Notice of Project Change

THE HUB ON CAUSEWAY

OFFICE TOWER

February 2018

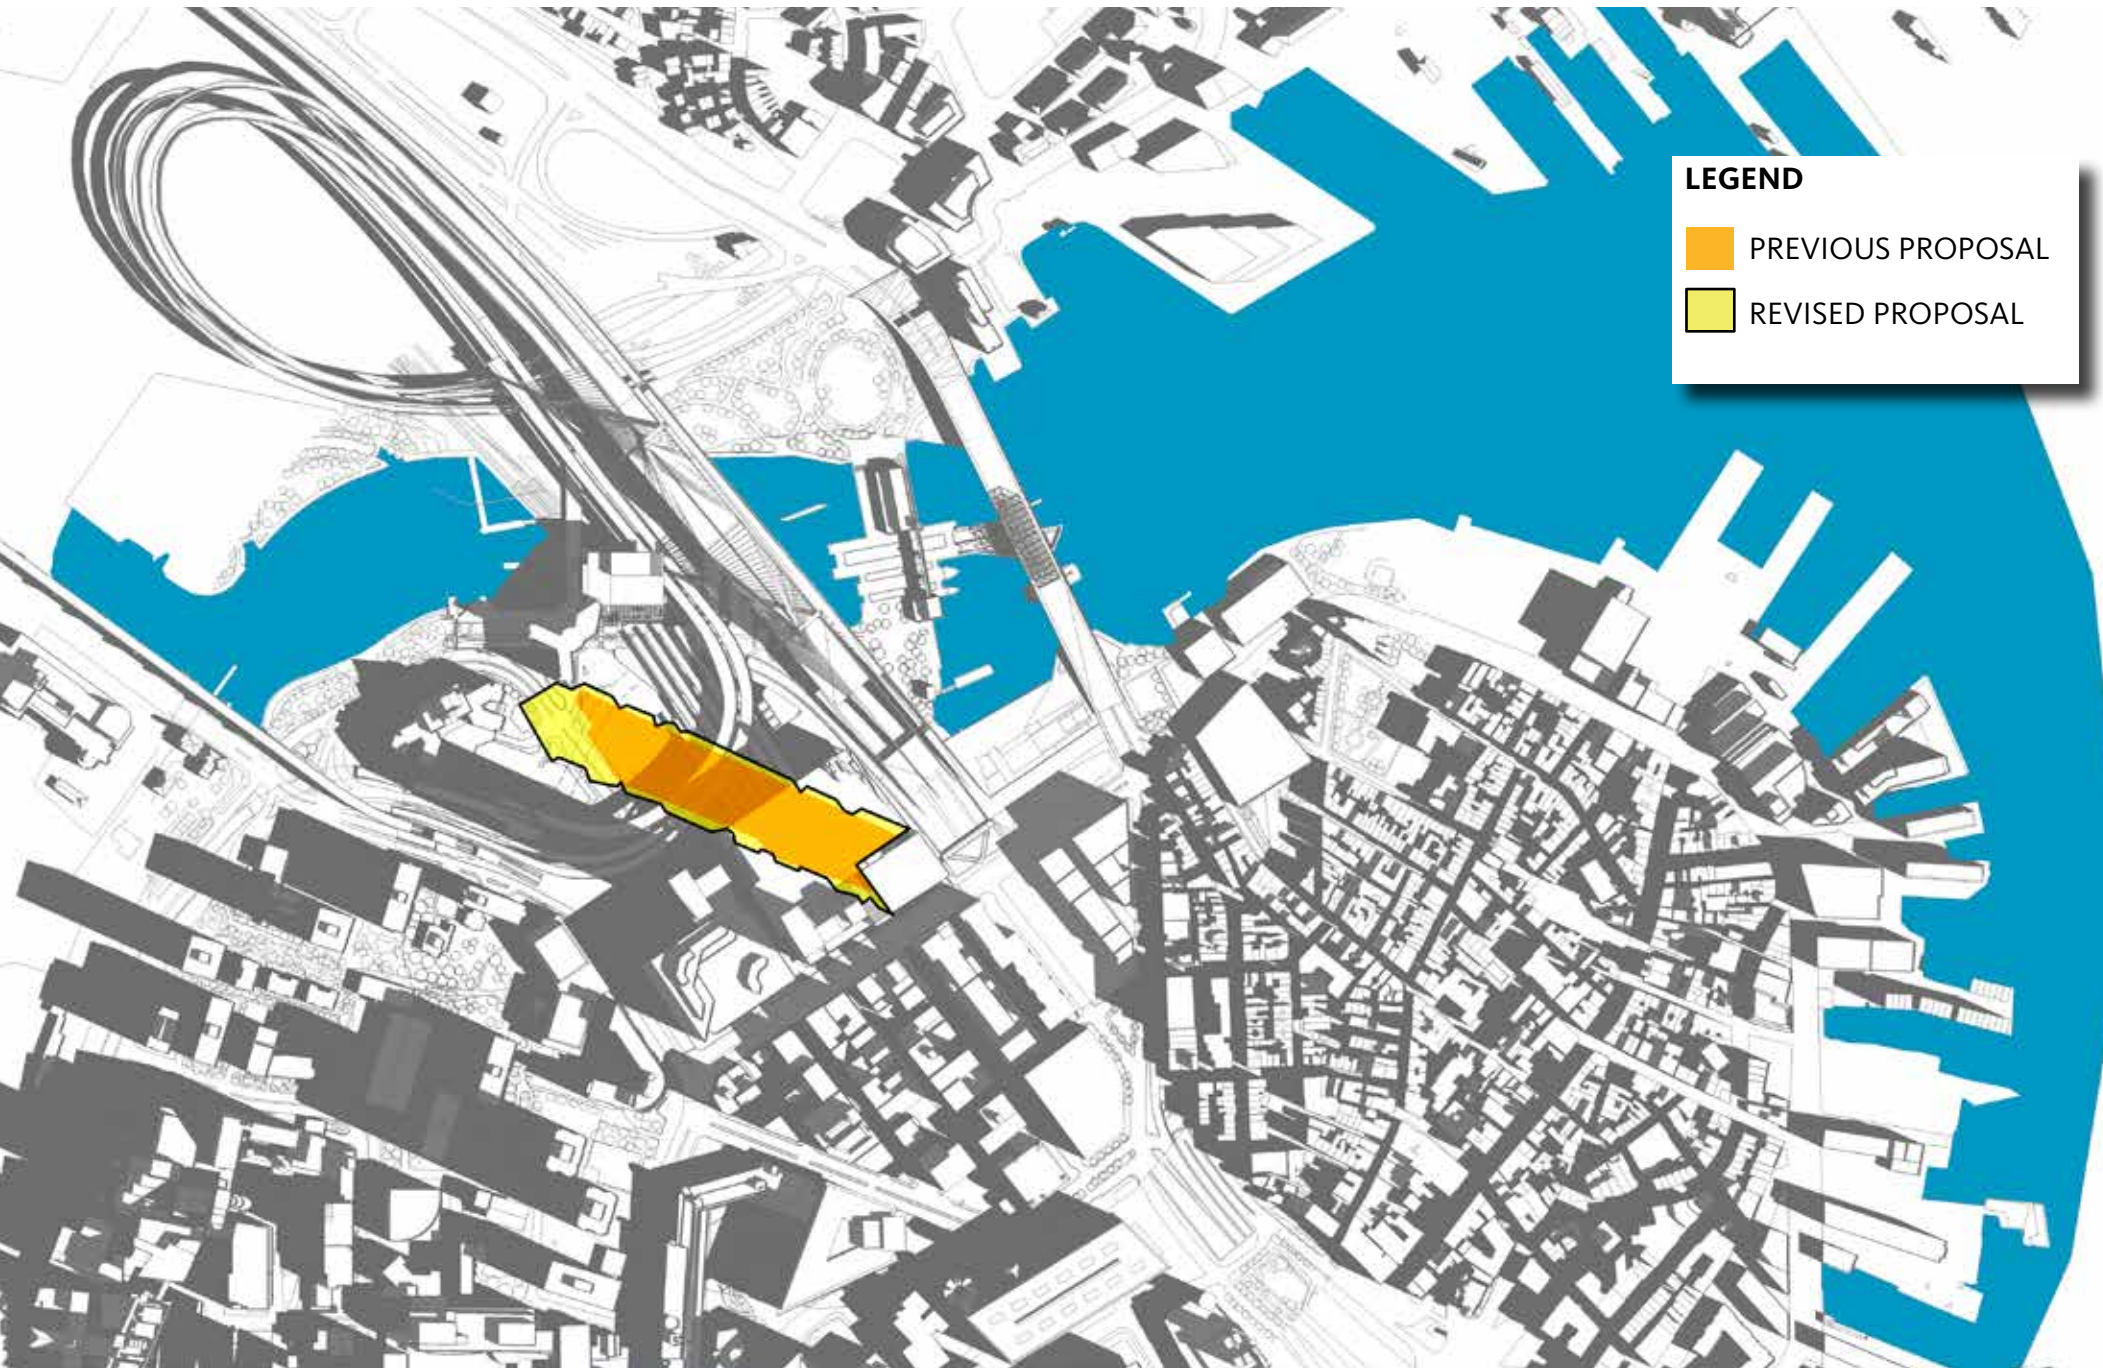
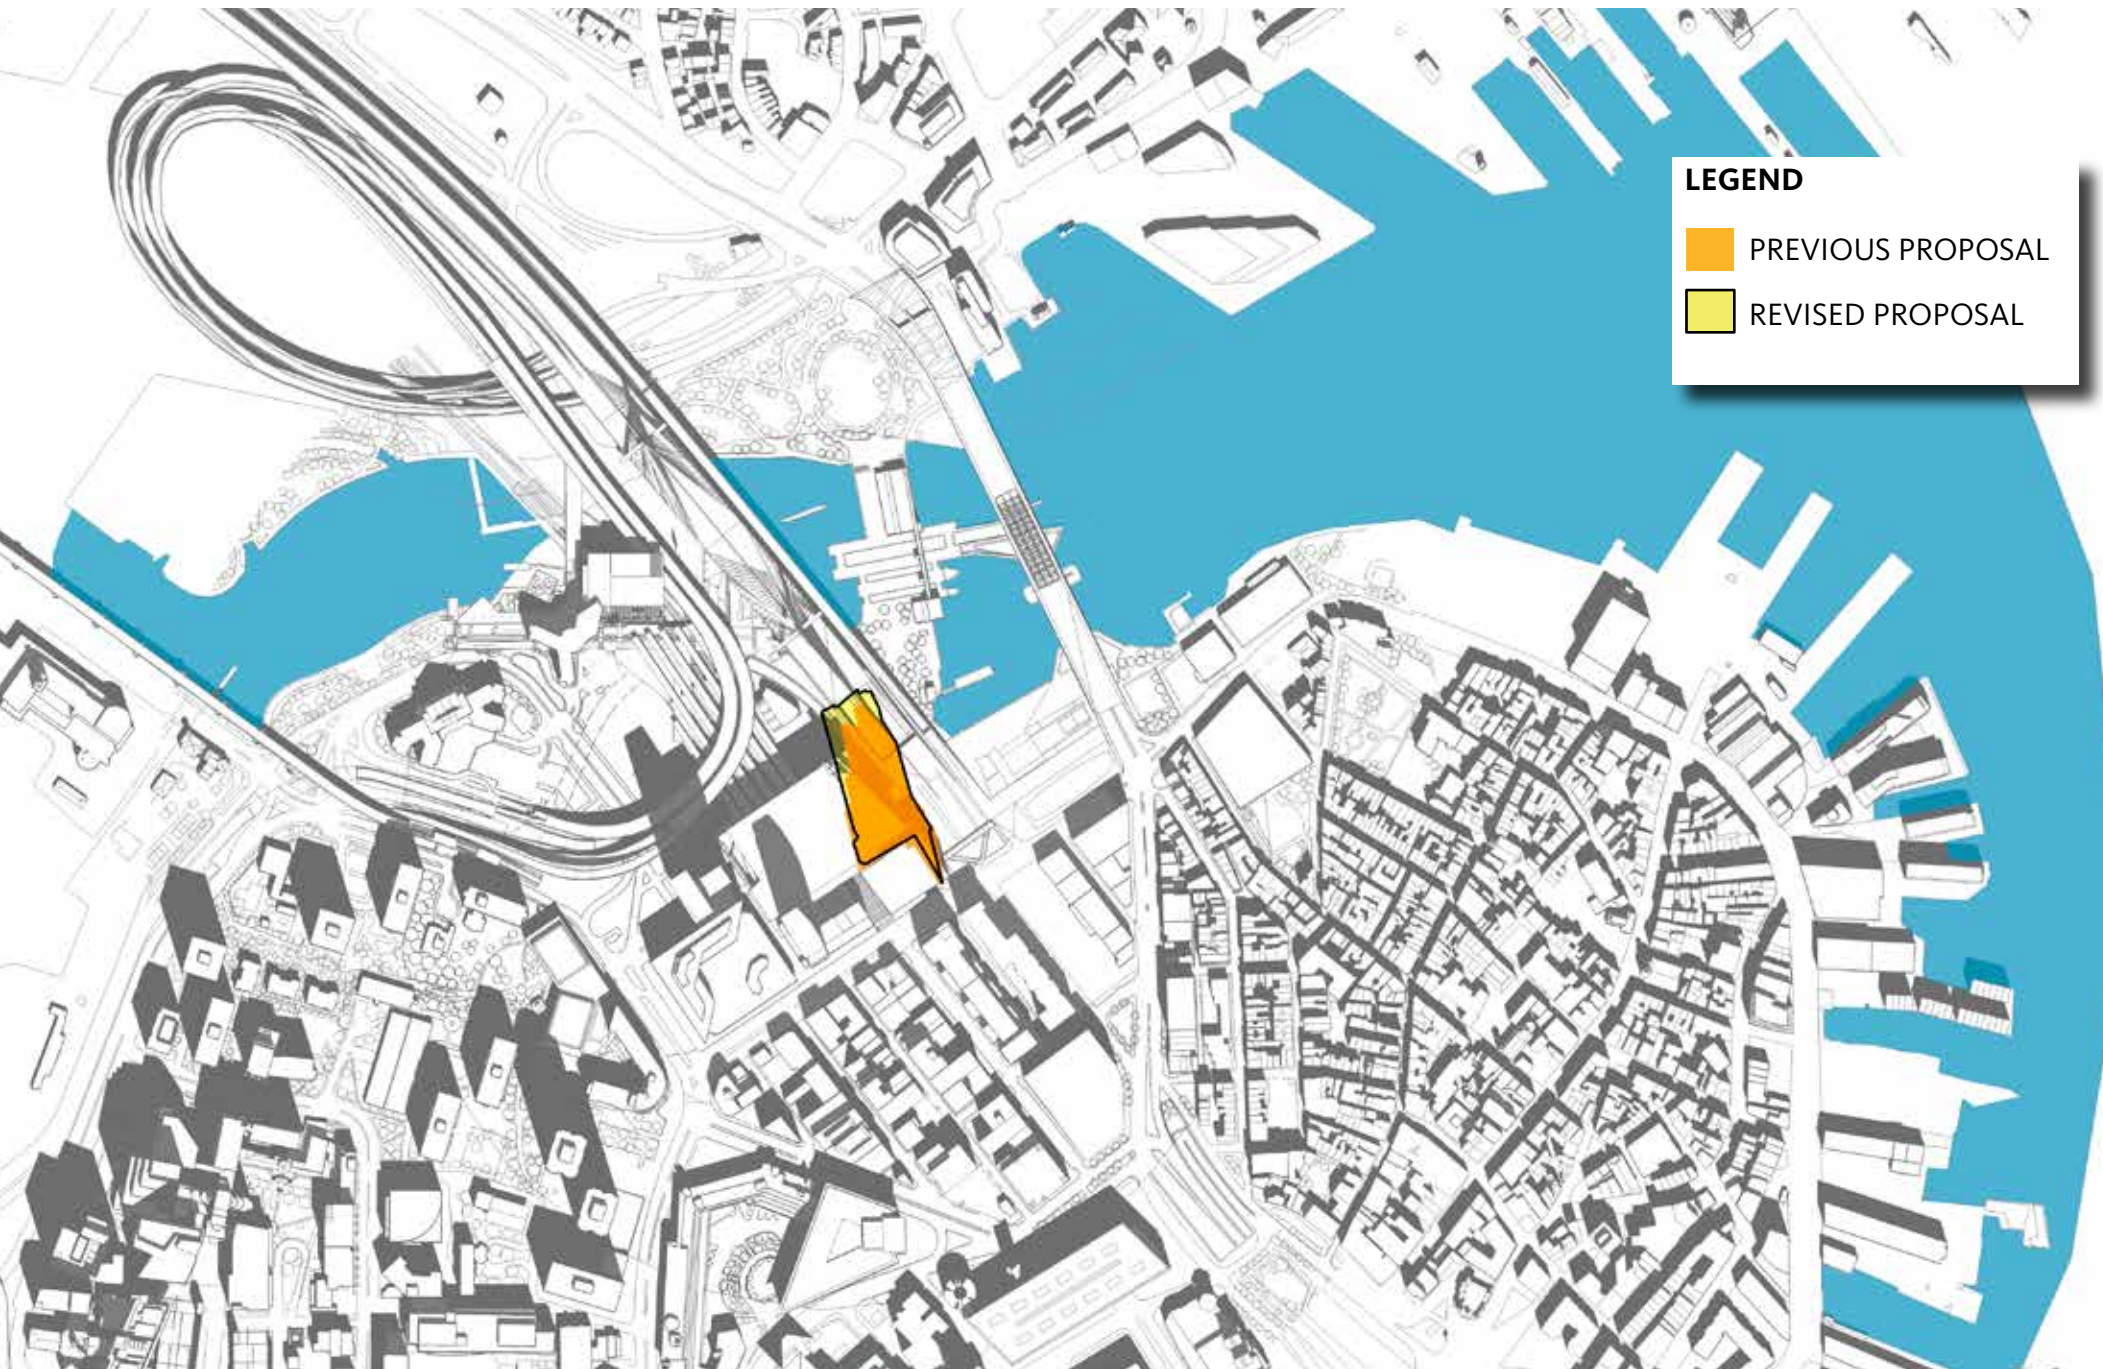
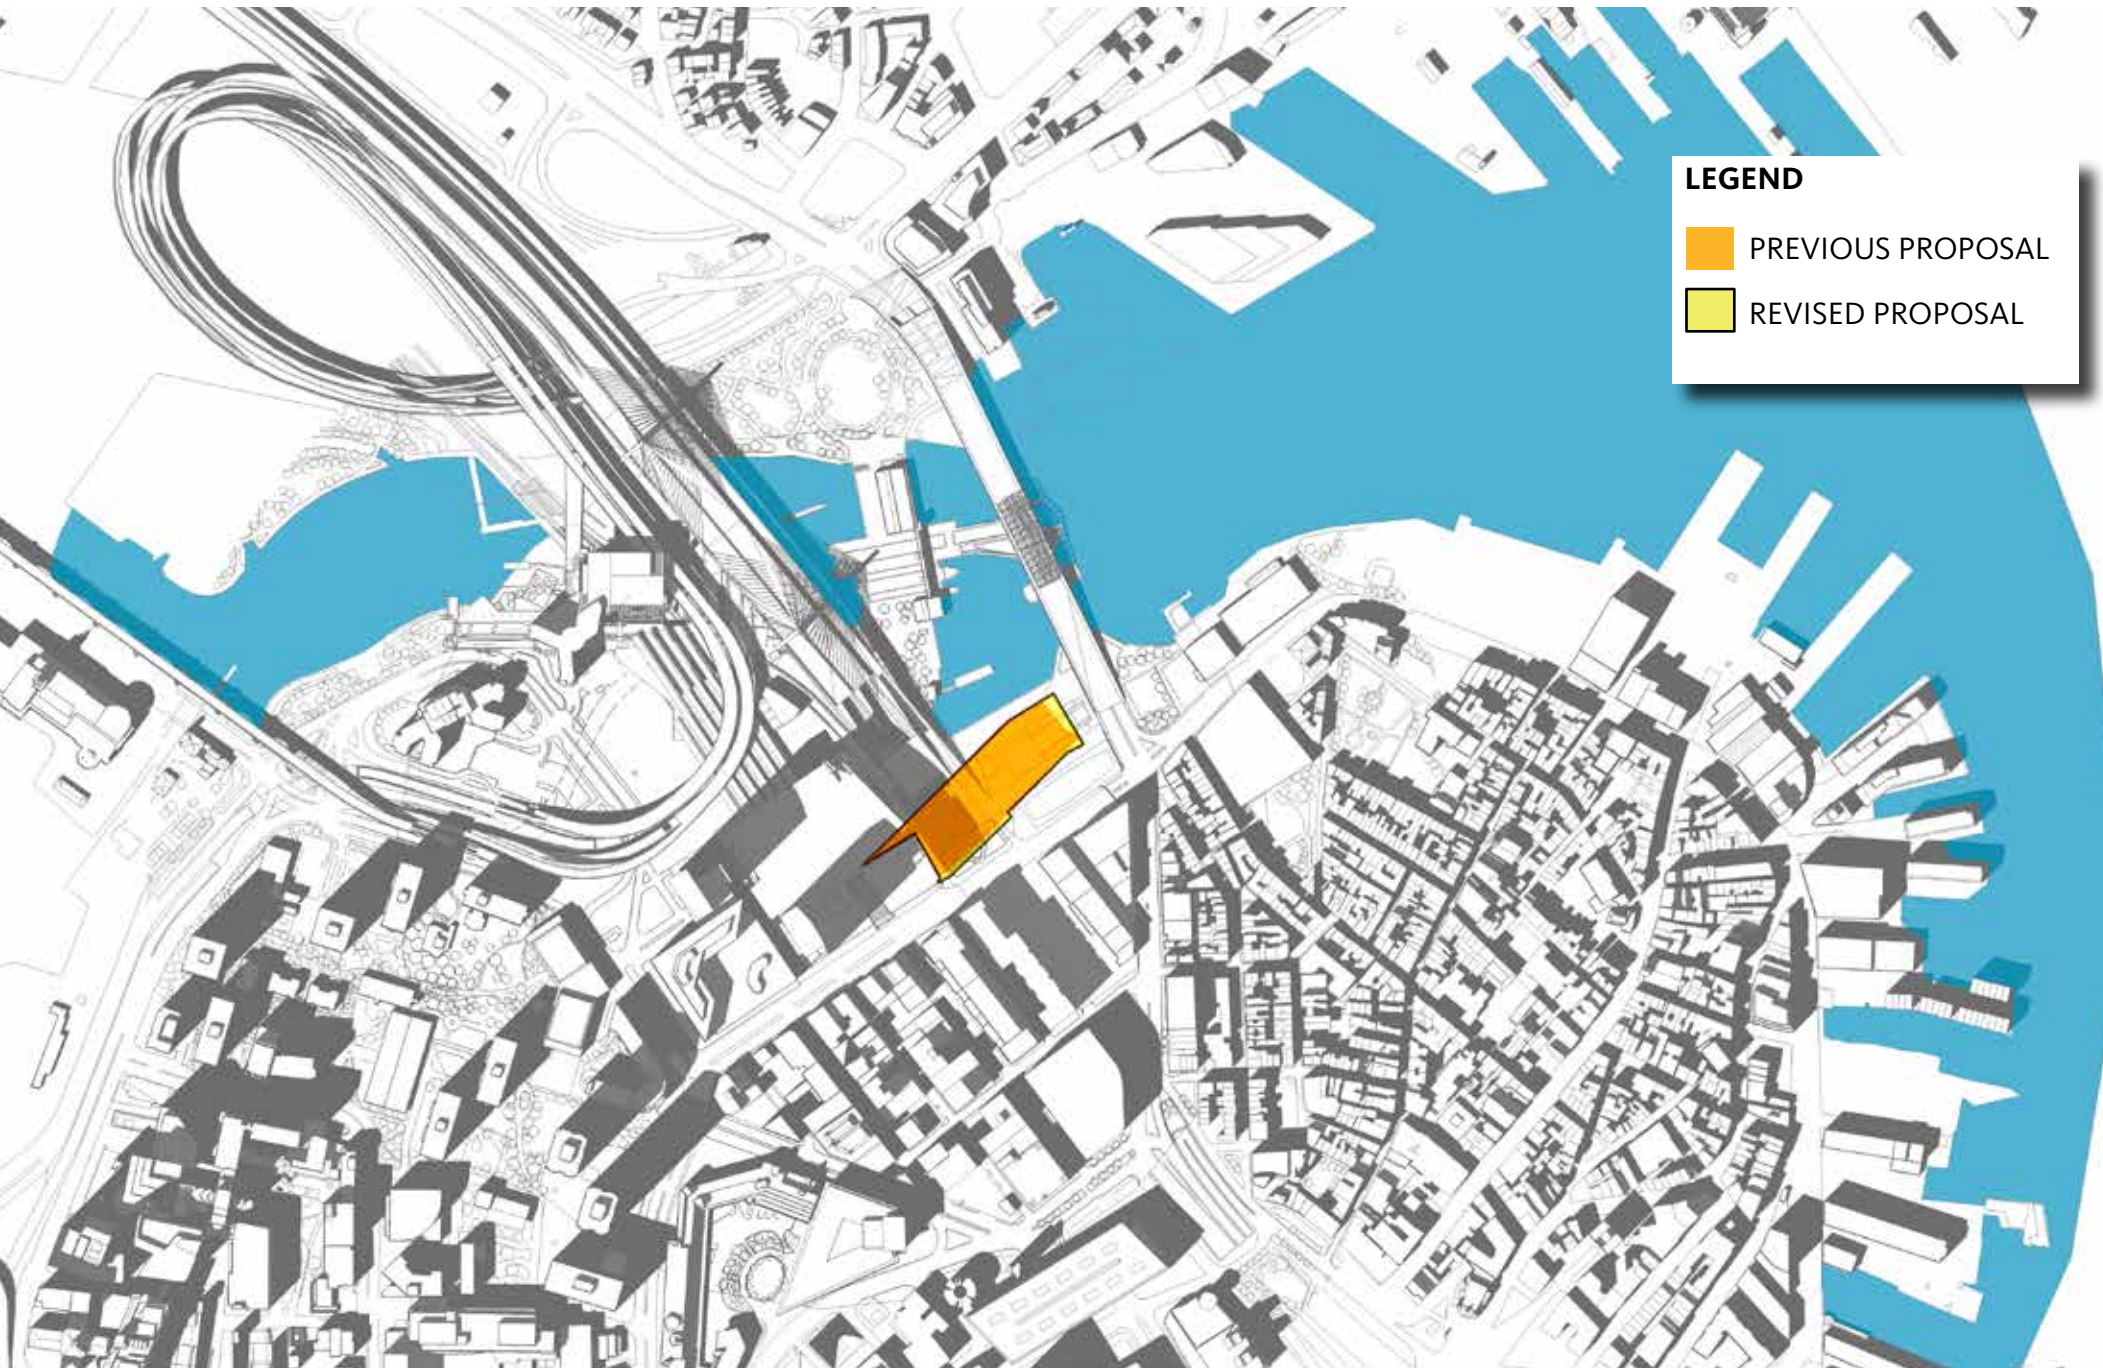
The new proposed Office Tower height of up to 495 feet is measured to the top of the highest occupiable floor. With the inclusion of an occupiable roof deck in the improved Office Tower design, the top floor (which previously was limited to mechanical equipment and was therefore excludable from the height calculation) is now included in height. This design change added approximately 30 feet to the height calculation for the Office Tower, without actually increasing

the physical height of the building. Overall, with the higher floor to ceiling expanses and the addition of one floor, the physical height of the Office Tower would be increased by about 45 feet (note: height calculated pursuant to the Boston Zoning Code would increase by approximately 75 feet). The increase in actual height, along with the expanded maximum floor plates, would result in a small extension of shadow, particularly during early morning, early evening and wintertime, when sun angles are low. Much of the additional shadow falls on areas such as the train tracks or areas already in shadow from other buildings. The updated Shadows Studies from the previous PNF Supplemental Information submittal dated December 6, 2013 (See Figures 4.B.1 through 4.B.13) show the previous Office Tower shadows in orange, with the proposed building shadow outlined and infilled with yellow. Changes in shadow are due in part to the different height, massing, positioning and orientation of the Office Tower on the Podium, and as mentioned above, are most differentiated when sun angles are low.
